Landscape Referral Response

Application Number:	DA2019/1190
Date:	29/05/2020
Responsible Officer:	Daniel Milliken
Land to be developed (Address):	Lot 1 DP 651395 , 9999 Pittwater Road BROOKVALE NSW 2100 Lot 1 DP 784268 , 9999 Pittwater Road BROOKVALE NSW 2100 Lot B DP 966128 , 9999 Pittwater Road BROOKVALE NSW 2100 Lot 6 DP 785409 , 9999 Pittwater Road BROOKVALE NSW 2100

Fig. 1 TPZ & SRZ overlay

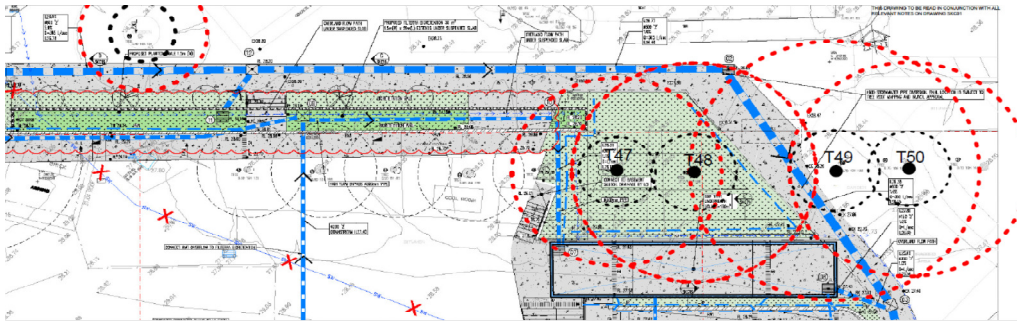
Concern is raised with regard to the impacts on trees proposed for retention adjacent to the stormwater works shown on the Storm Water and Site Works Concept Plan Dwg No. C05-2 A prepared by TTW.

Review of the proposed works in accordance with AS4970-2009 *Protection of trees on development sites* indicates significant impacts on Trees T47, T48 and T49 which would render them unsuitable for retention. Fig. 1 below indicates the Tree Protection Zone (Red dash circle) and Structural Root Zone (Black dash circle) overlaid on to the stormwater drawing.

Based on the TPZ of each tree as identified in the applicant's Arborist report, the following impacts have been calculated.

- T47:** TPZ radius 7.9m; TPZ area 196m²; Works incursion 74m² = **38% of TPZ**
T48: TPZ radius 9.2m; TPZ area 266m²; Works incursion 125m² = **47% of TPZ**
T49: TPZ radius 10.9m; TPZ area 373m²; Works incursion 74m² = **37% of TPZ**

These impacts are considered too great to enable retention of trees T47, 48 and 49.

Fig. 2 Swept path drawing

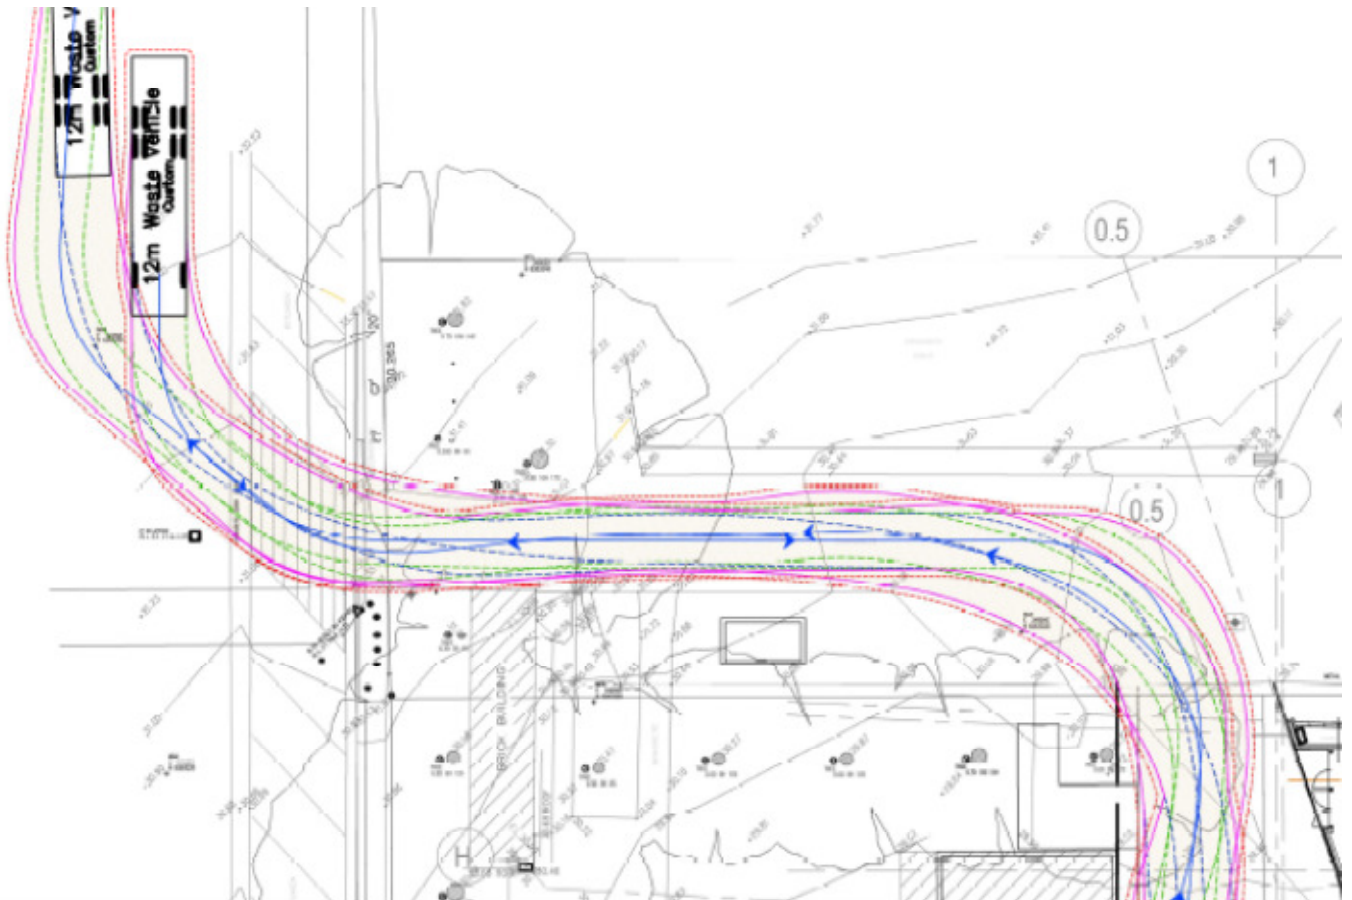
A drawing has been provided indicating the swept path for waste service truck to access the site (Fig 2 below). Several trees (including one heritage listed tree) are close to the routes indicated and it is unclear if additional hard paving areas are required to accommodate the trucks. It is likely that additional pruning would be required and there is potential for ongoing trunk damage given the close proximity of the tracked path to the tree trunks. The existing entry arrangement is indicated on Photo 1 below. This may be able to be addressed through further information, however the plan again highlights the ongoing impact of the development on the existing trees.
